Midland Knitwear Ltd. (9511)

Ramarbagh, Kutubpur, Fatullah, Narayangonj, Bangladesh

08.APRIL.2014

Identified Priority 1 Concerns

1st Priority 1 Concern (Continued)

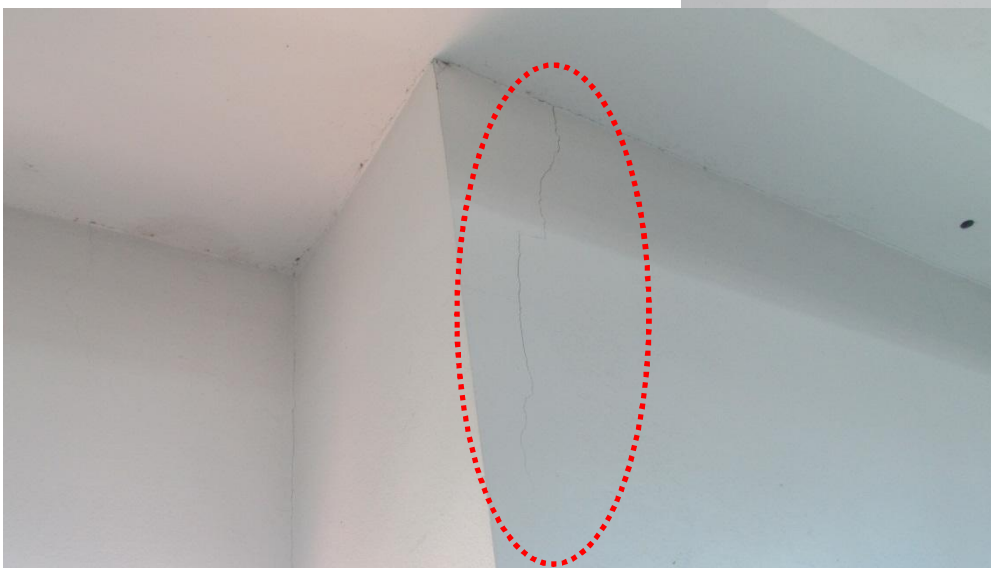
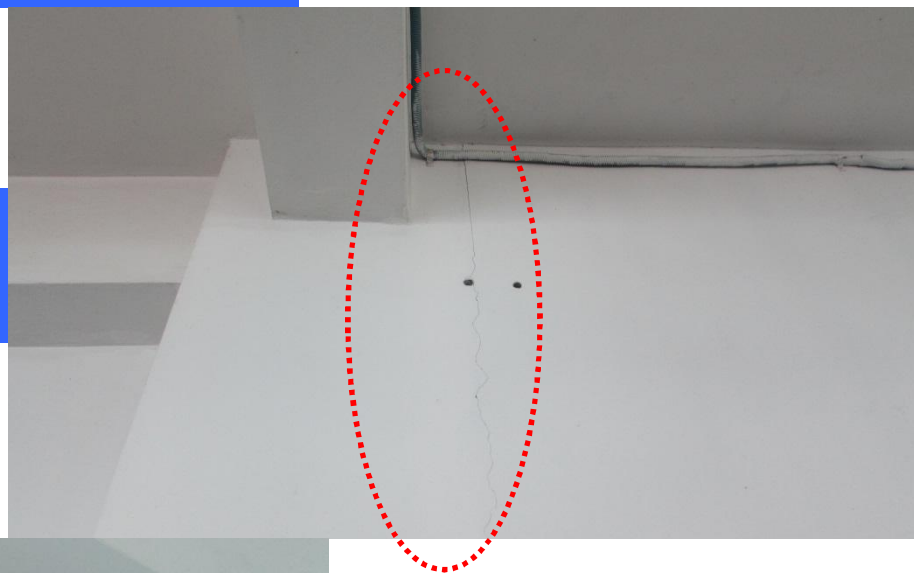
The provided loading plan shows the water tank at 2000Kg. However the actual weight of water tank on the roof floor was noted at 5000Kg

- Mark the maximum allowable height of fabric stacking to ensure full compliance
- Building engineer to verify the loading capacity of the roof beams of building 1 to support the water tank of 5000Kg
